ORIGINATION FORM

Proposed Revisions to a Standard Plans Index (Please provide all information – Incomplete forms will be returned)

Contact Information:		Standard Plans:	
Date: November 28, 2017		Index Number: 000-506	
Originator: Derwood Sheppard		Sheet Number (s): 1 of 1	
Phone: (850) 414-3443		Index Title: Miscellaneous Earthwork Details	
Email: derwood.sheppard@dot.state.fl.us			
Summary of the changes:			
Renumbered Index to 160-001; Updated Notes; Reorganized sheet; Moved REMOVAL OF EXCESS BASE MATERIAL detail to Index 120-001.			
Commentary / Background:			
Yes No	Other Affected Offices / Documents: (F	Provide name of responsible personnel)	
	Other Standard Plans – Derwood Sheppar	rd	
	FDOT Design Manual –		
	Basis of Estimates Manual –		
	Standard Specifications –		
	Approved Product List –		
	Construction –		
	Maintenance –		
V 81/8	Origination Package Includes: (Email or h	nand deliver package to Derwood Sheppard)	
Yes N/A	Redline Mark-ups		
	Proposed Standard Plan Instructions (SPI)		
	Revised SPI		
	Other Support Documents		
Implementation:

REMOVAL OF EXCESS BASE MATERIAL

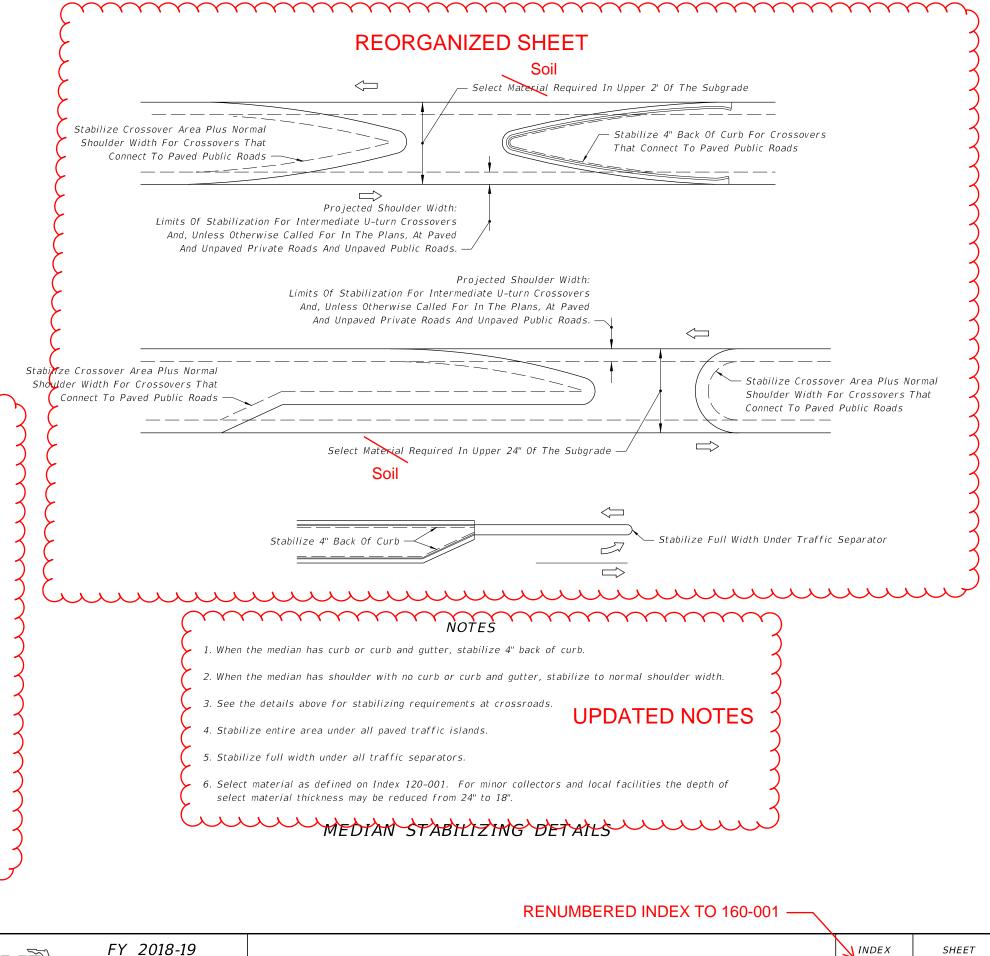
MOVED TO INDEX 120-001
